Generic design assessment of new nuclear power plants

Other environmental regulations for the UK HPR1000 design - AR08

Detailed assessment – final report

10 January 2022

Figure 1: Requesting Party flow diagram for liquid radioactive effluent streams (GNSL, 2021a)

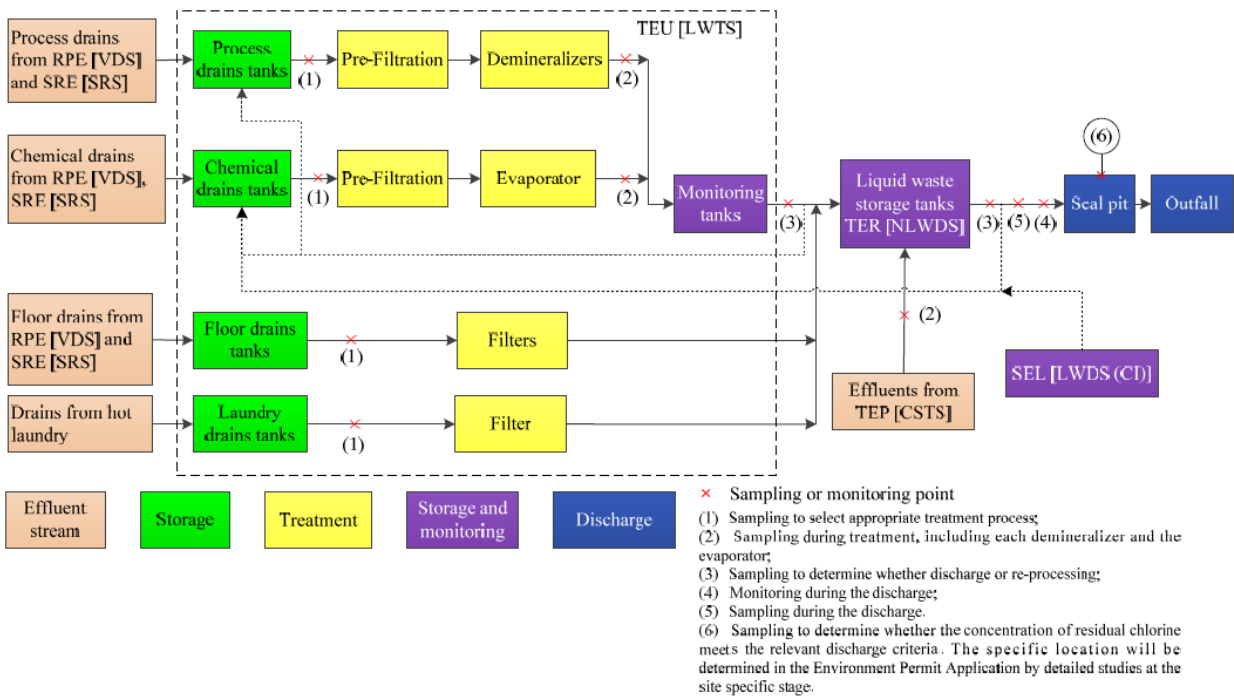
These effluent streams are managed and treated separately up to the point at which they enter the Nuclear Island Liquid Waste Discharge System (NLWDS) - see Figure 1 below. Treatment of these effluent streams takes place in the Liquid Waste Treatment System (LWTS). The process drain effluents are treated by demineralisation, chemical drain effluents are treated by evaporation, and the floor and laundry drains are treated by filtration. The treatment options for these effluents are intended to treat radioactive as well as chemical contaminants. We considered that there was not enough detail in the Pre-Construction Environmental Report (GNSL, 2021a) on the treatment techniques proposed for the LWTS, so we raised a question in RQ-UKHPR1000-0546 to seek more information.

We noted that the flow diagrams provided (see Figure 1 above and Figure 2 below) included the option to either discharge the effluent directly into the environment (via the seal pit) or to divert it to be treated in the LWTS. We queried what controls would be in place when deciding to divert an effluent stream that would normally go directly to the seal pit for discharge to the treatment plant at the LWTS instead (RQ-UKHR1000-0546). The RP confirmed that the effluent is expected to be non-radioactive for the majority of the time but may, on occasion, become contaminated by small leakages of radioactivity from the primary to the secondary circuit.

The RP’s response provided some more information on the evaporation, filtration and demineralisation units, which we considered to be at an acceptable level of detail for GDA.

Figure 2: Requesting Party flow diagram for potentially radioactive effluent streams (GNSL, 2021a)

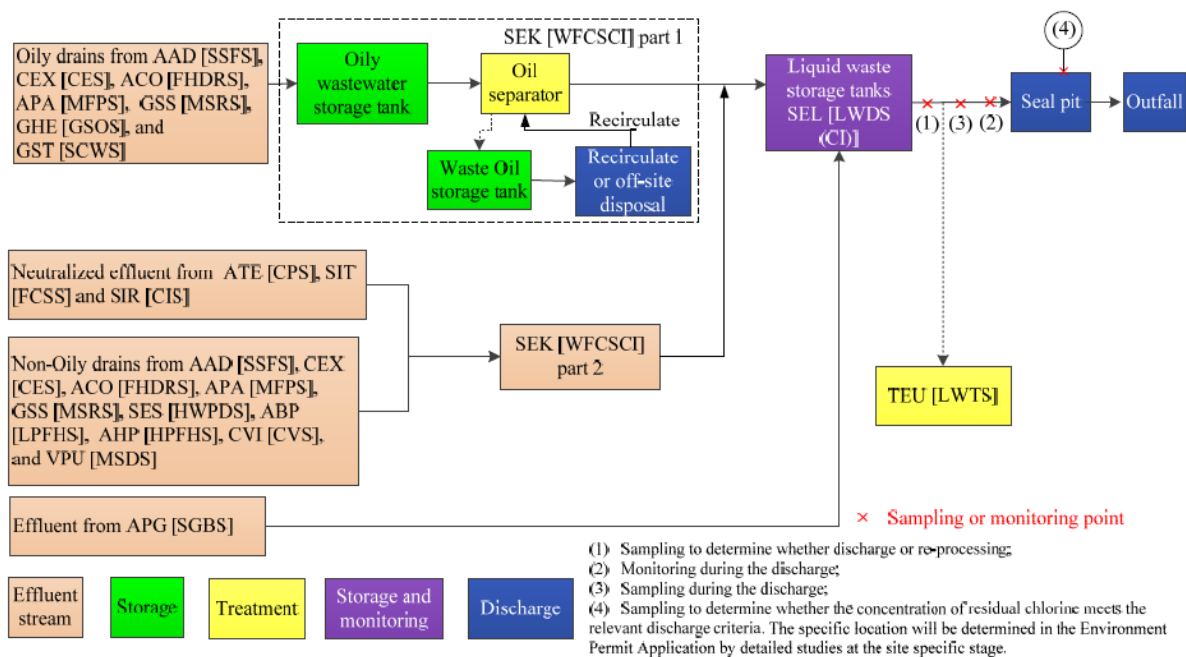
Figure 2 below shows the systems that are used to manage potentially radioactive effluents from the turbine hall (Waste Fluid Collection System for Conventional Island - WFCSCI) and Steam Generator Blowdown System (SGBS) before they go to the Conventional Island Liquid Waste Discharge System (LWDS(CI)). The turbine hall effluents also have the potential to be oily, so the WFCSCI is split into 2 parts: part 1 treats the potentially oily wastes, while part 2 deals with the non-oily effluents. The potentially radioactive, oily effluents are treated by conventional oil/water separation techniques, which remove the oil fraction from the effluent stream which is then dealt with separately by off-site recovery or disposal. The remaining water fraction is sampled in storage tanks in the LWDS(CI) and then either released for discharge via the seal pit or directed to the appropriate treatment facility in the LWTS (see Figure 1 and Figure 2).
